DOCKETED	
Docket Number:	18-IRP-01
Project Title:	Integrated Resource Plan
TN #:	268208
Document Title:	Review of Riverside Public Utilities 2023 Integrated Resource Plan
Description:	N/A
Filer:	Mikayla Roberts
Organization:	California Energy Commission
Submitter Role:	Commission Staff
Submission Date:	1/9/2026 2:09:56 PM
Docketed Date:	1/9/2026

STAFF REPORT

Review of Riverside Public Utilities 2023 Integrated Resource Plan

January 2026 | CEC-200-2026-001

Figure 2: RPU Preferred Portfolio Forecast for Annual Electricity Demand

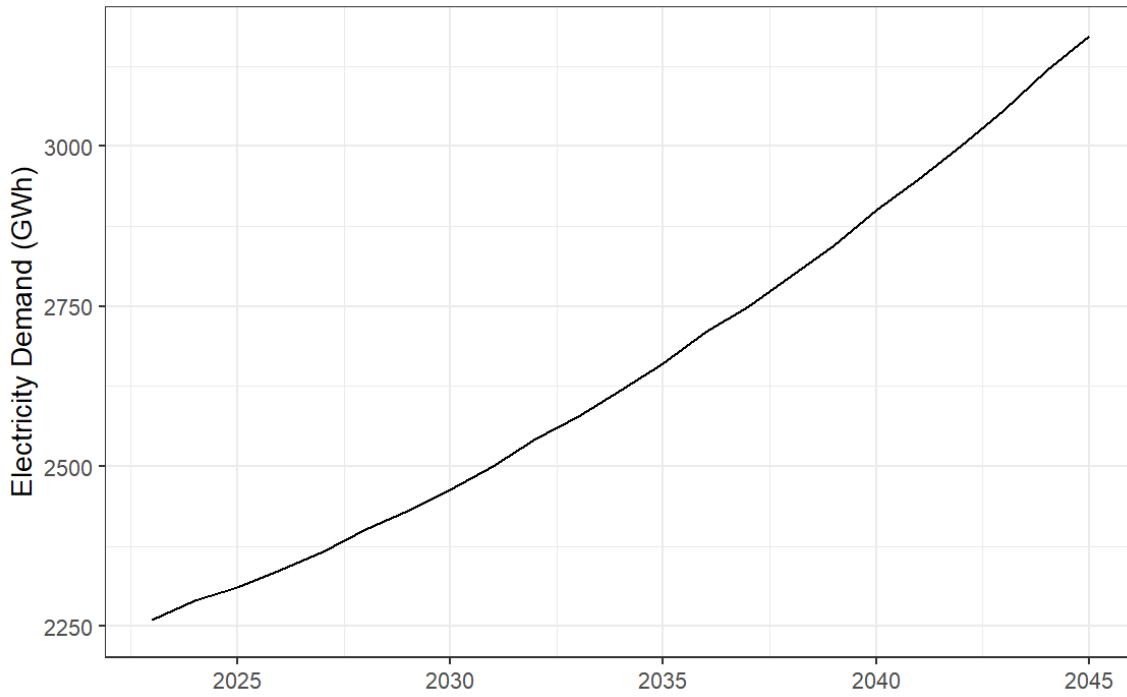
RPU summed the monthly total load results for all twelve months in each year to forecast the utility's total annual demand for electricity for the years 2023-2045, as shown in **Figure 2**. In the peak demand model, RPU used the model results for August as the peak demand for each year between 2023 and 2045. **Figure 3** shows the annual peak demand, plus a planning reserve margin which is 15 percent for 2023 and 2024 and 17 percent thereafter. The forecasted annual electricity demand for 2023 is 2,261 GWh; for 2030, 2,464 GWh; and for 2045, 3,172 GWh. The forecasted peak demand, plus planning reserve margin, for 2023 is 686 MW; for 2030, 721 MW; and for 2045, 818 MW.

CEC staff compared RPU's energy and peak demand forecast to the Energy Commission's 2023 Demand Forecast Update report. CEC's forecast for annual RPU demand between 2022 and 2040 ranges from 2.75 percent less to 2.5 percent more than the RPU forecast, depending on the year. So, the RPU forecast can be considered to be within a reasonable range.

Figure 4: Risk Integrated Portfolio Cost: Baseline A and B Portfolios

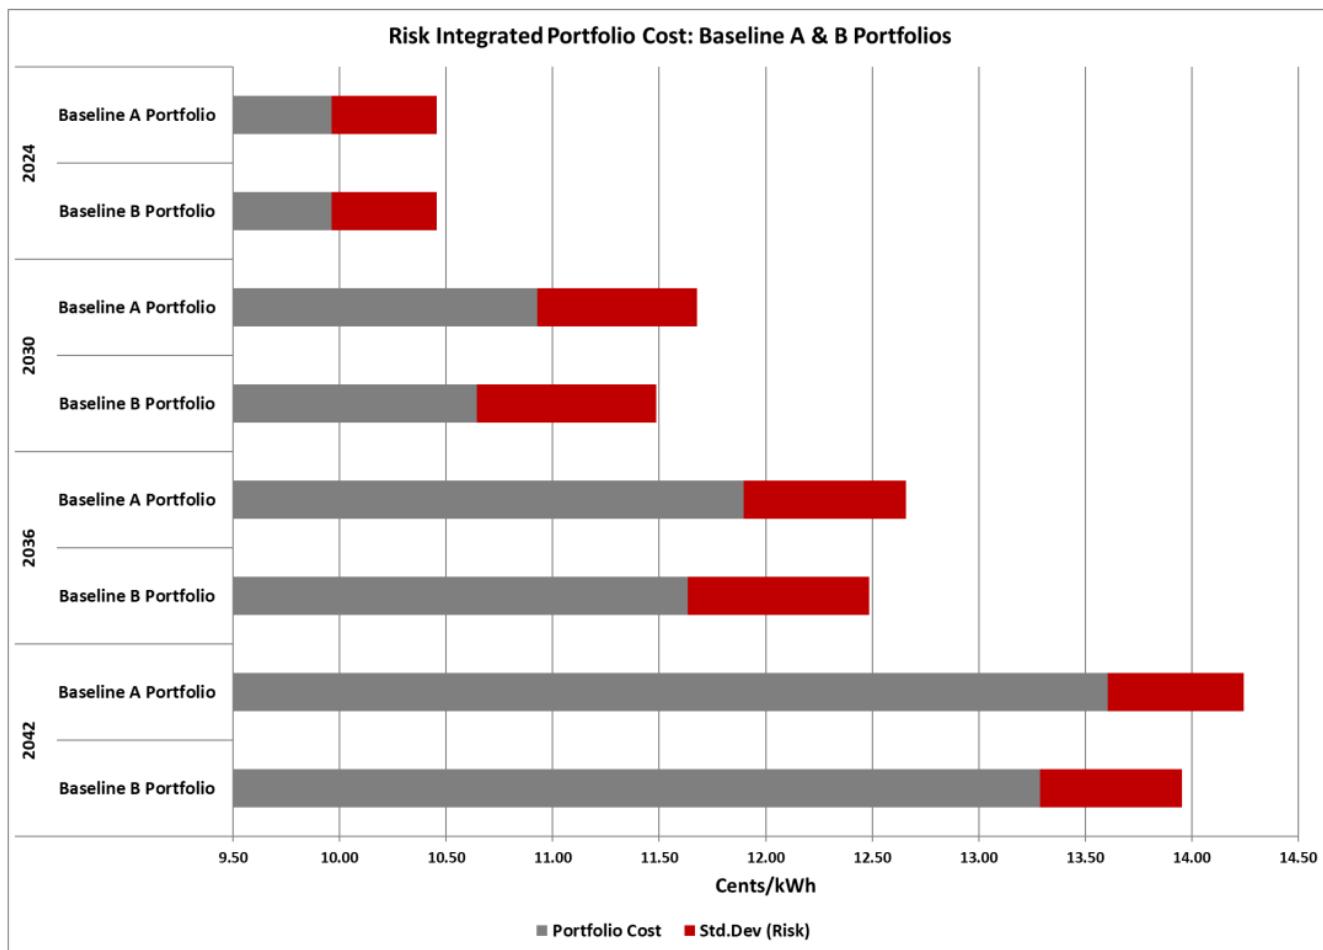
RPU determined that the utility would need to procure an additional renewable resource, starting in 2030, that can provide 367,920 MWh of energy and 50 MW of capacity at peak. The utility considered two portfolio resource options to meet these requirements: Baseline A, which adds a geothermal resource; or Baseline B, which adds a solar resource paired with battery storage. RPU then calculated the RIPC for these two portfolios for the years 2030, 2036, and 2042. The utility also examined whether the Baseline A or Baseline B portfolio would better match demand on average. The portfolio with Baseline B, solar and storage, was found to have a one to two percent lower RIPC than the portfolio with Baseline A, the geothermal resource (**Figure 4**). However, the portfolio with the geothermal resource was found to yield an energy supply that better matches the utility's energy demand, on average. For this reason, RPU selected the portfolio with Baseline A as its preferred resource portfolio.
